NORTHEAST UTILITIES

Docket No. 50-423
B10845

Millstone Nuclear Power Station, Unit No. 3:
Response to Select Requests for Additional Information

NRC Letter: May 3, 1983

FIGURE 2.5.4-43
LATERAL PRESSURE DISTRIBUTION
 MILLSTONE NUCLEAR POWER STATION
 UNIT 3
 FINAL SAFETY ANALYSIS REPORT

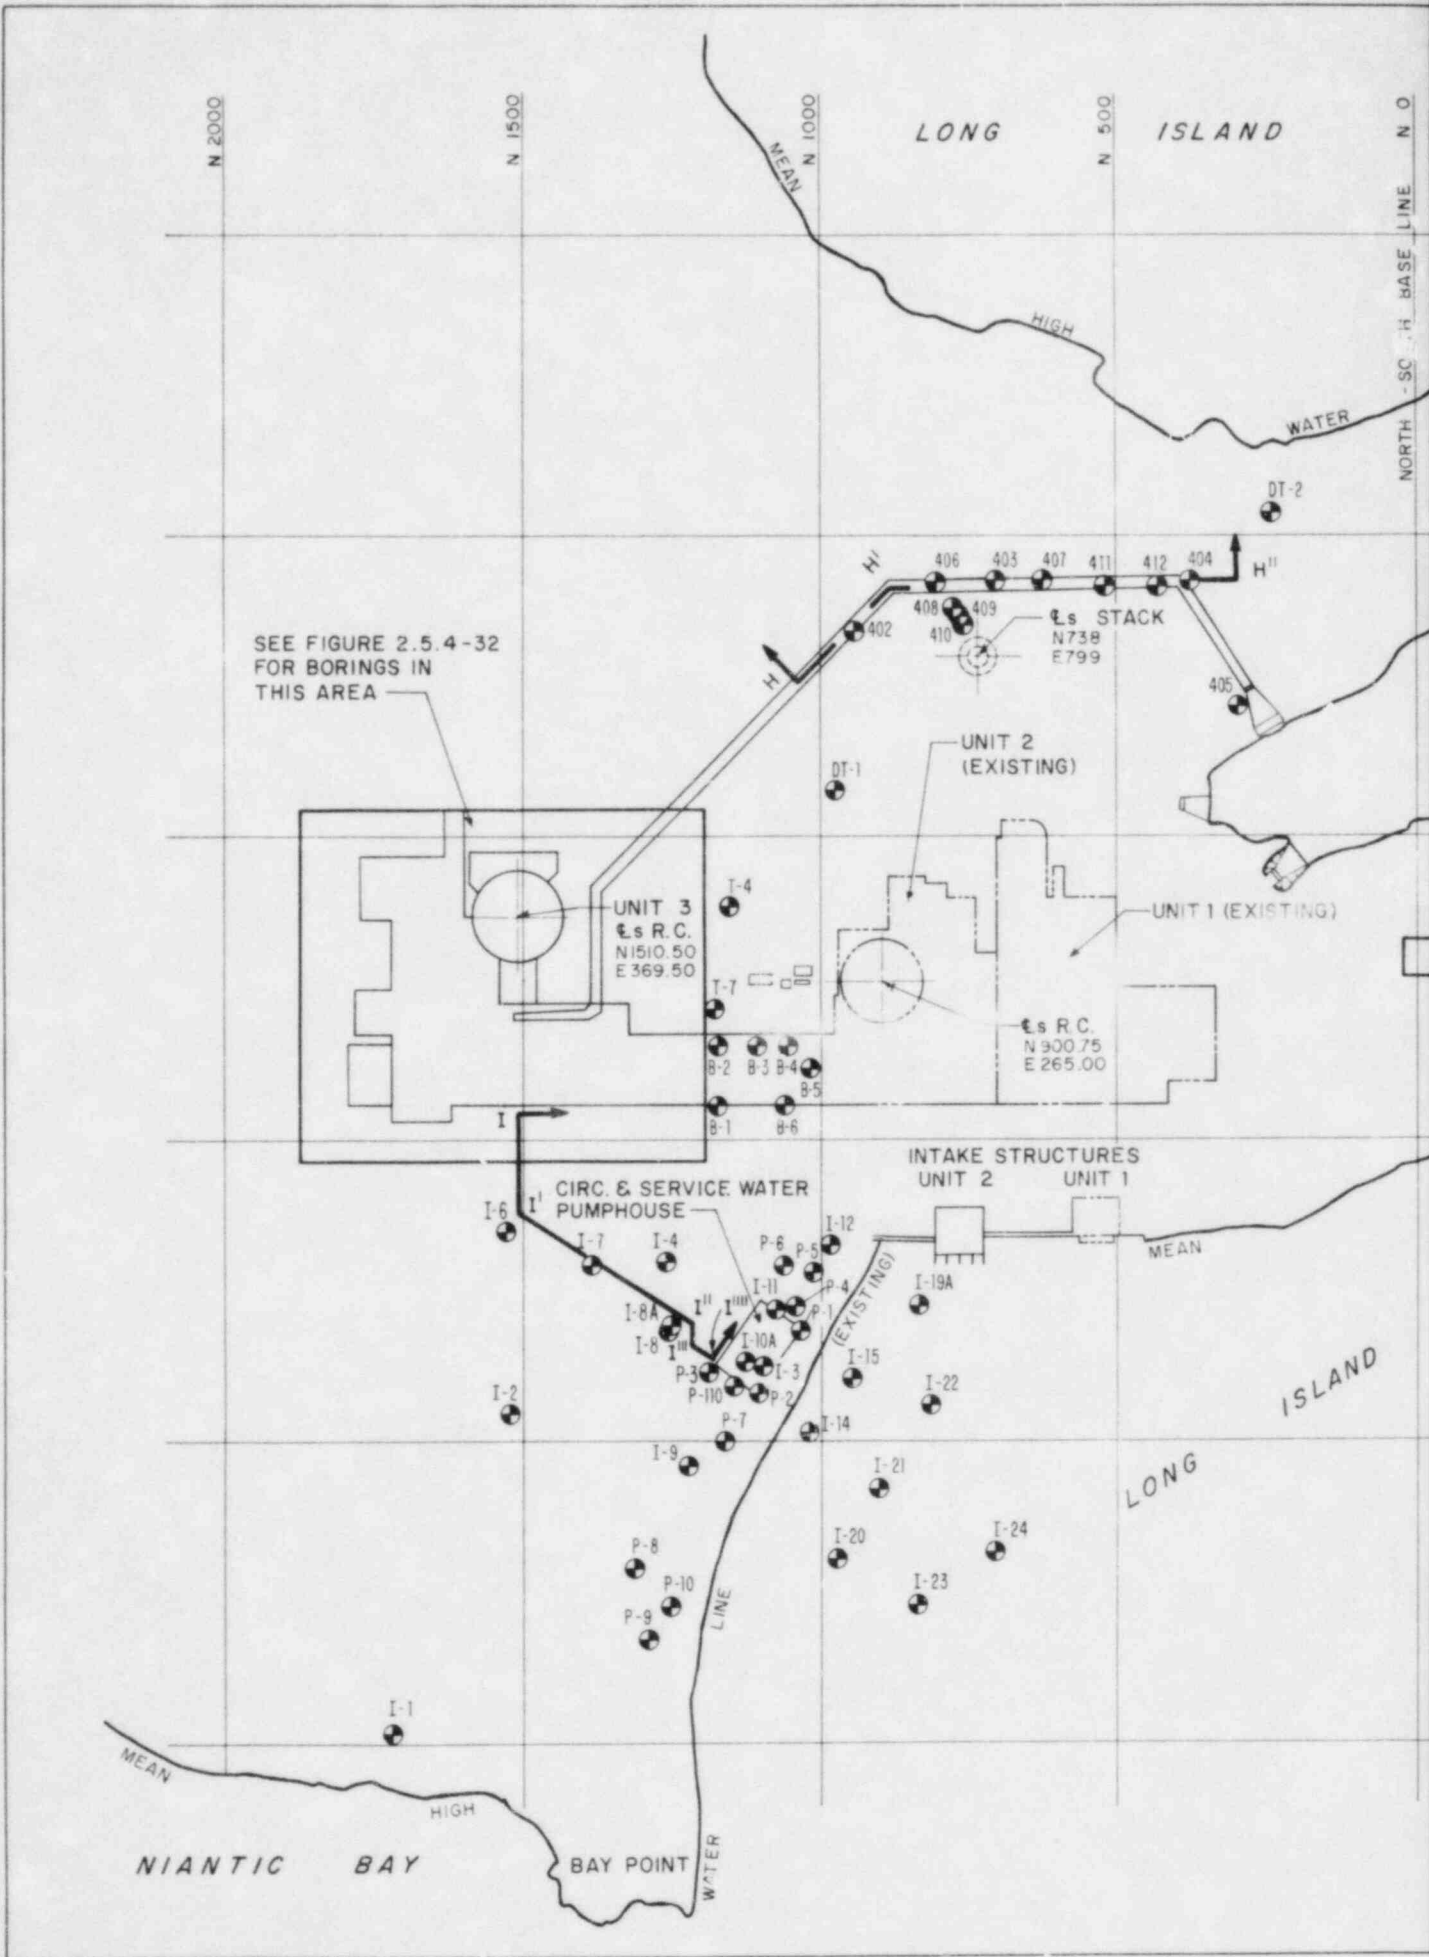
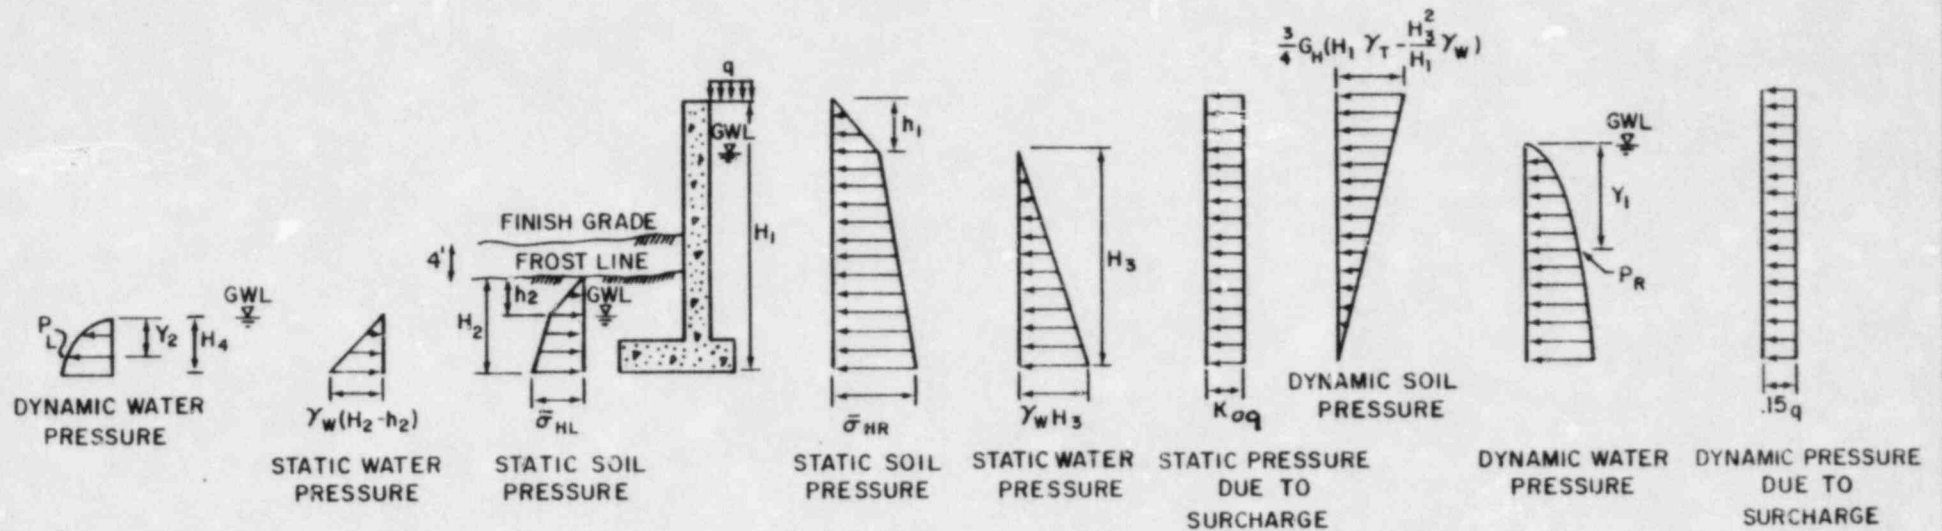
Question No. Q241.16 (Section 2.5.4.10.3 and SRP Section 2.5.4)

FSAR Figure 2.5.4-43 shows the lateral pressure distribution used in designing rigid unyielding foundation walls. The figure has been revised to correct errors and to add the unit weight of backfill. Also, FSAR Section 2.5.4.10.3 has been changed to correct typographical errors.

FIGURE 9.1-6 (1 OF 1)
 FUEL POOL COOLING &
 PURIFICATION SYSTEM
 MILLSTONE NUCLEAR POWER STATION
 UNIT 3
 FINAL SAFETY ANALYSIS REPORT

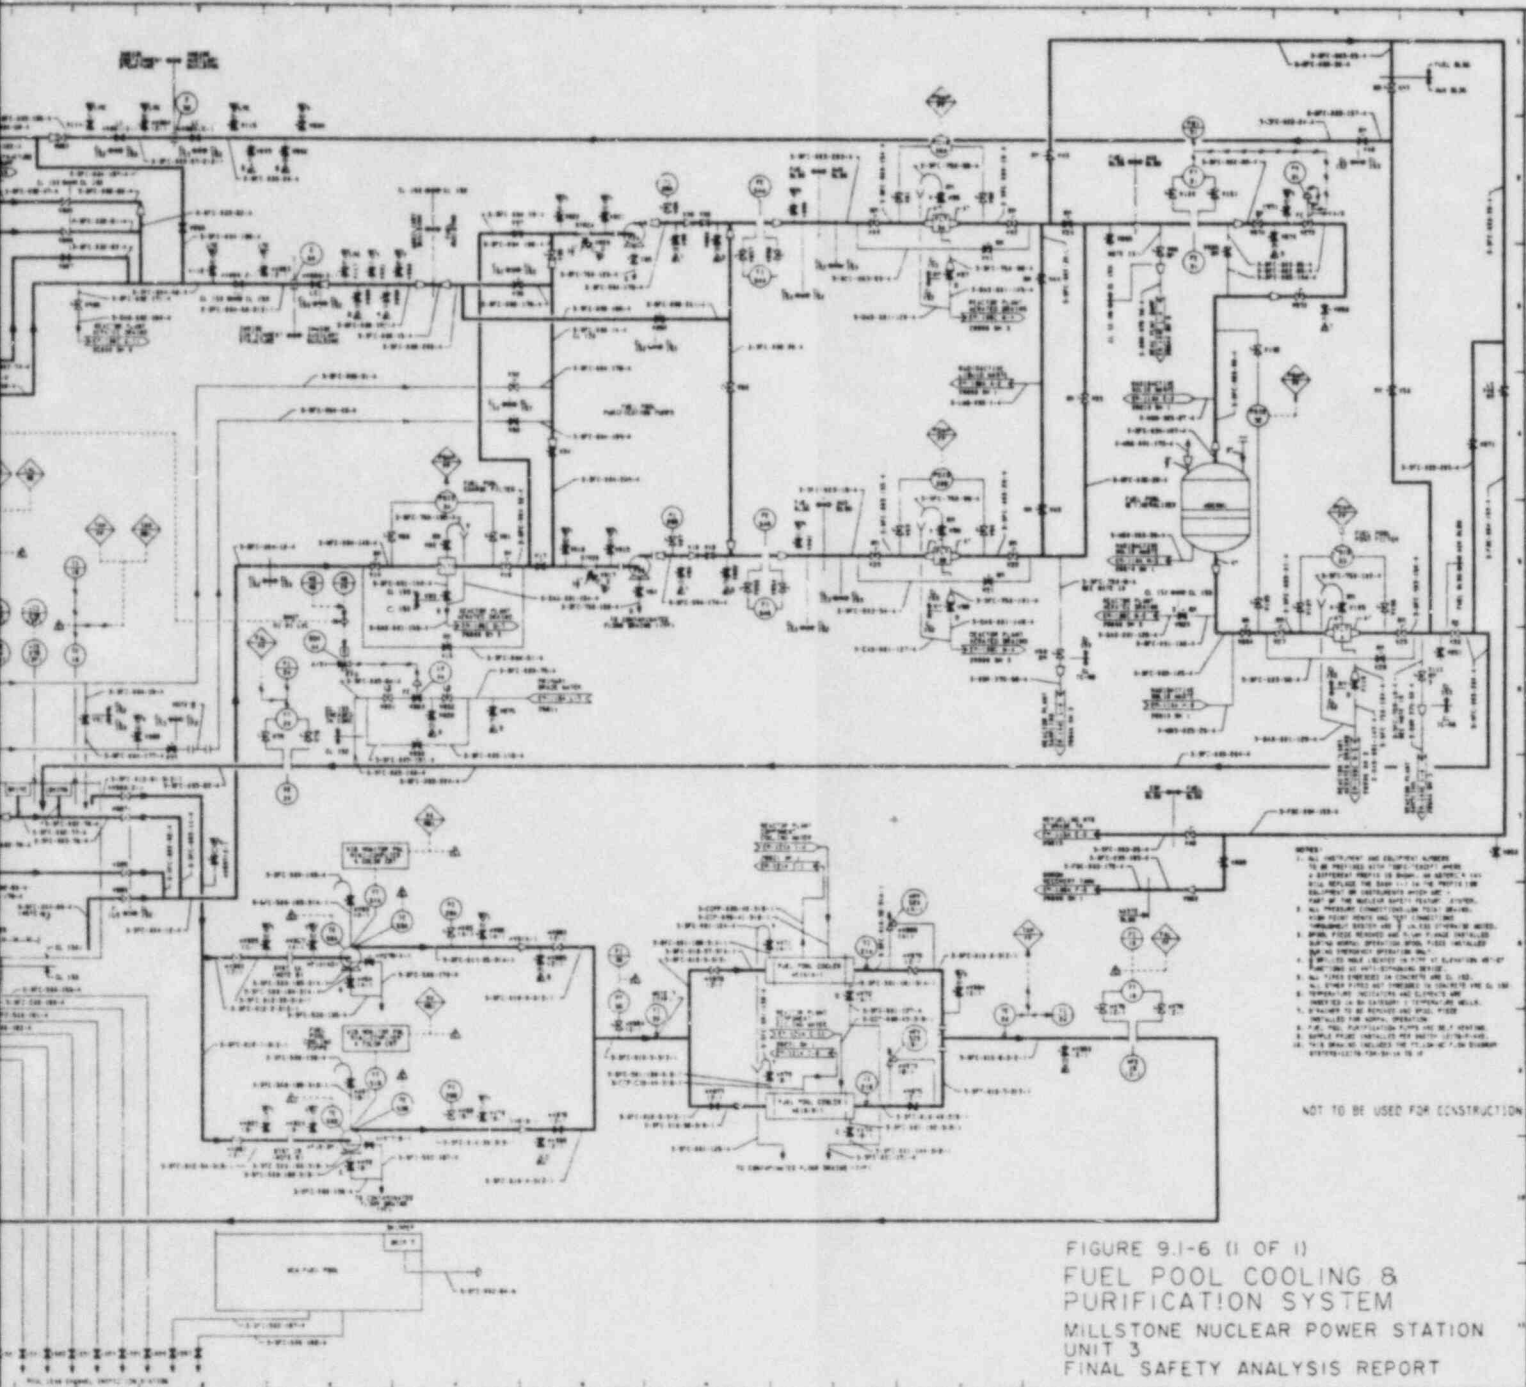
Question No. Q410.14 (Section 9.1.3)

Refer to revised FSAR Section 9.1.3.3, and Figure 9.1-6 for the response to this question.

FIGURE 10.3-1 (2 OF 4)
MAIN STEAM
AND REHEAT SYSTEM
MILLSTONE NUCLEAR POWER STATION
UNIT 3
F NAL SAFETY ANALYSIS REPORT

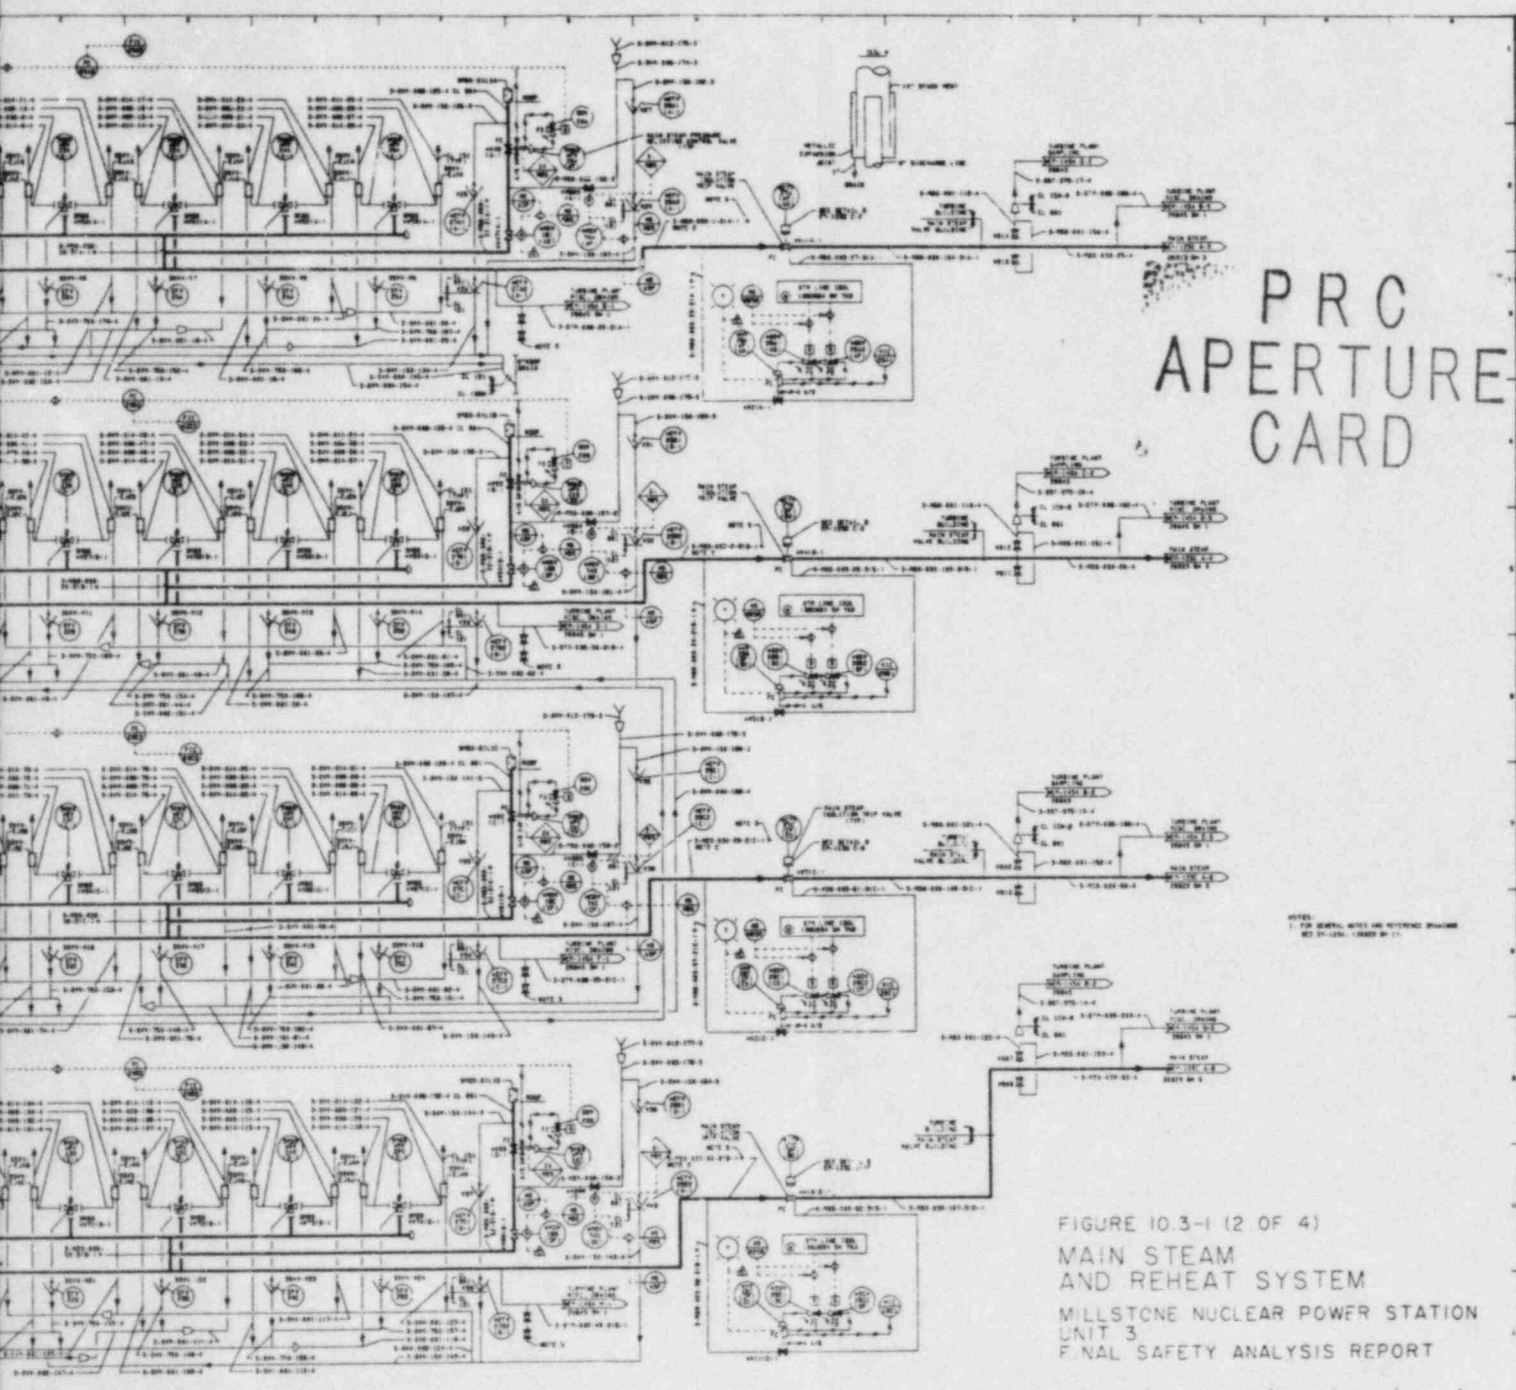
Question No. Q410.23 (Section 10.3.3)

FSAR Figure 10.3-1 has been revised to delete this block valve.

FIGURE 8.3-4
POWER SUPPLY
THIRD CHARGING PUMP
MILLSTONE NUCLEAR POWER STATION
UNIT 3
FINAL SAFETY ANALYSIS REPORT

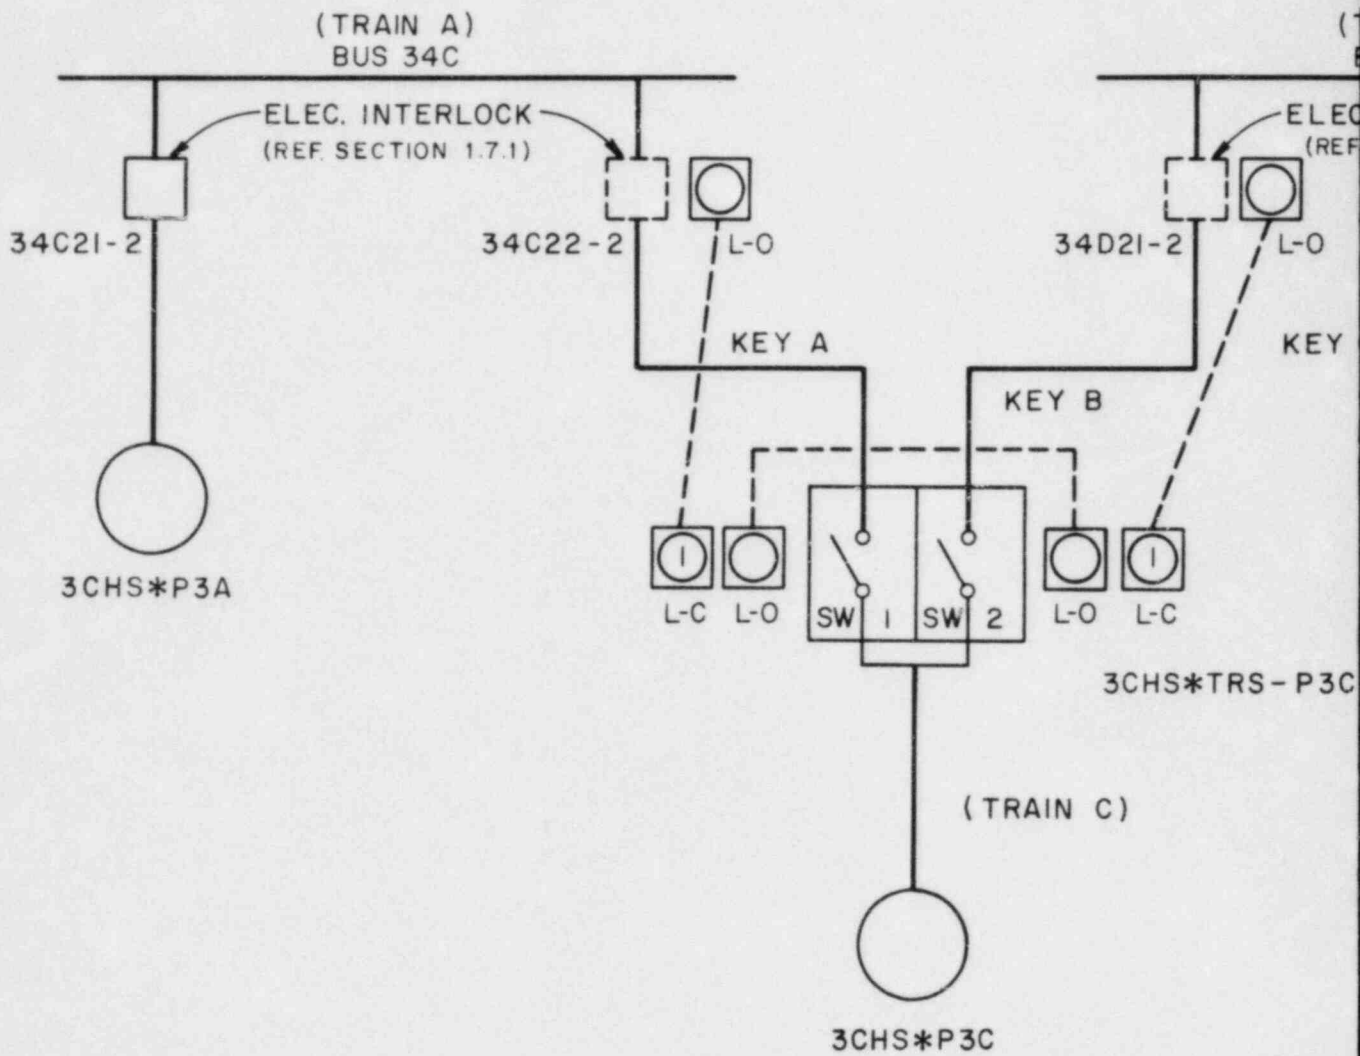
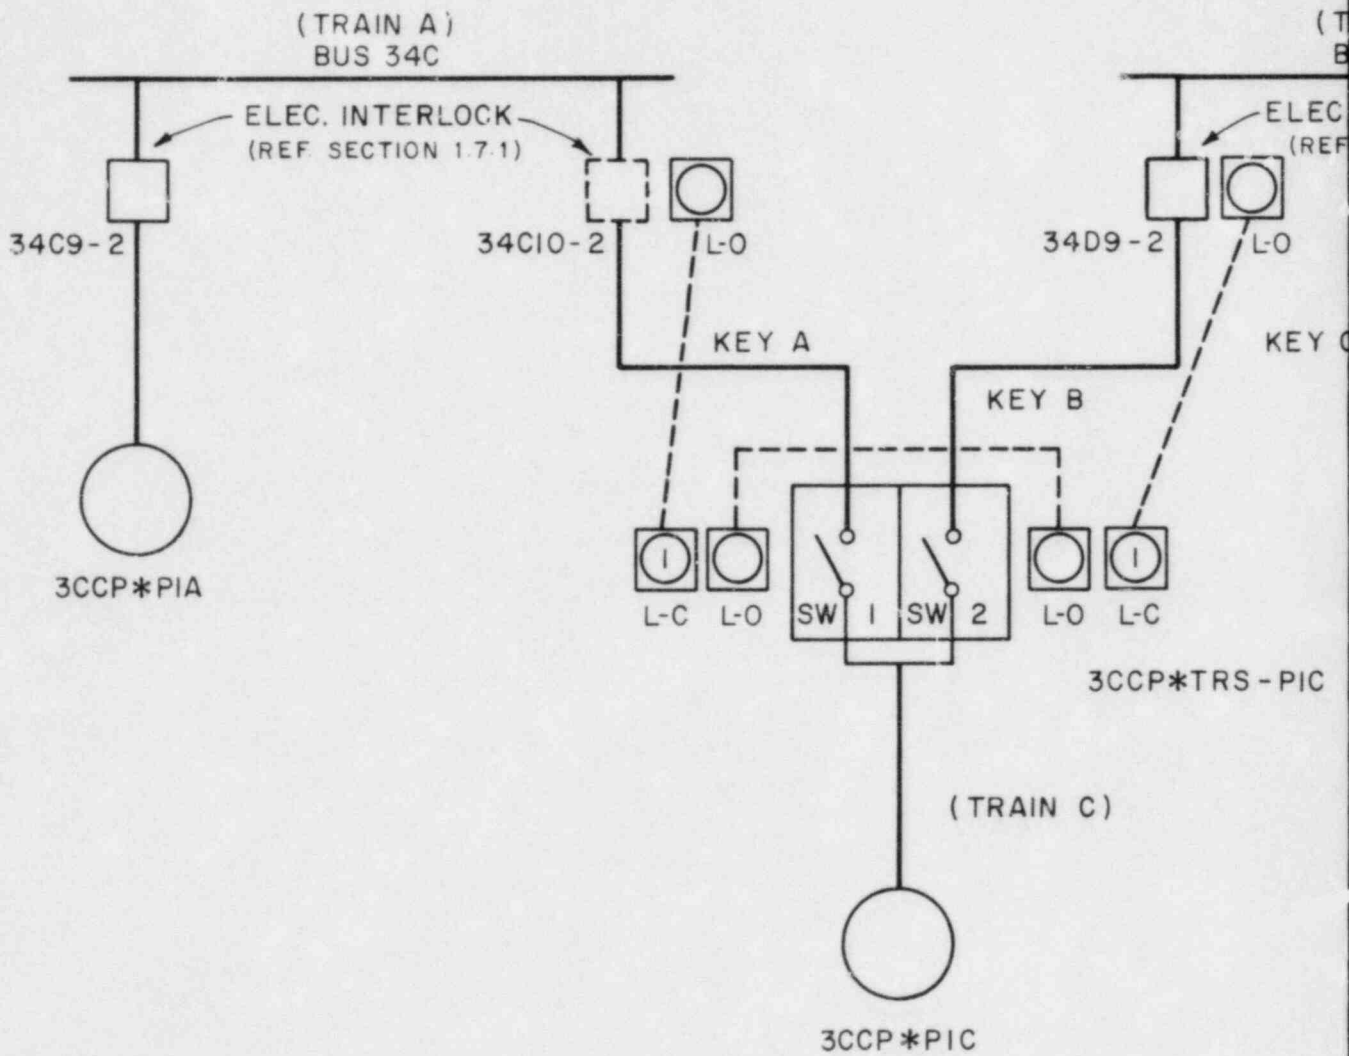
Question No. Q430.31 (SRP Sections 8.3.1 and 8.3.2)

Refer to revised FSAR Section 8.3.1.1.2 and revised FSAR Figures 8.3-4 and 8.3-5 for the response to this question.

Power for running the third charging pump is supplied from either emergency bus 34C (Train A) or 34D (Train B) (Figures 8.1-1 and 8.3-4). A manually operated transfer switch is provided to connect the pump to the selected bus. A feeder breaker cubicle is provided on each bus for connection to the transfer switch. Normally, these breaker cubicles do not have a breaker installed. Upon failure of or due to required maintenance of one of the two connected charging pumps, its circuit breaker will be removed from its switchgear cubicle and installed in the switchgear cubicle in the same bus for the third pump. Interlocks are provided to ensure that only one of the third pump power sources can be energized at any one time. Thus, at no time can the two emergency buses be tied together. Additional interlocks are provided to ensure that only one pump on an emergency bus can be energized at any one time.
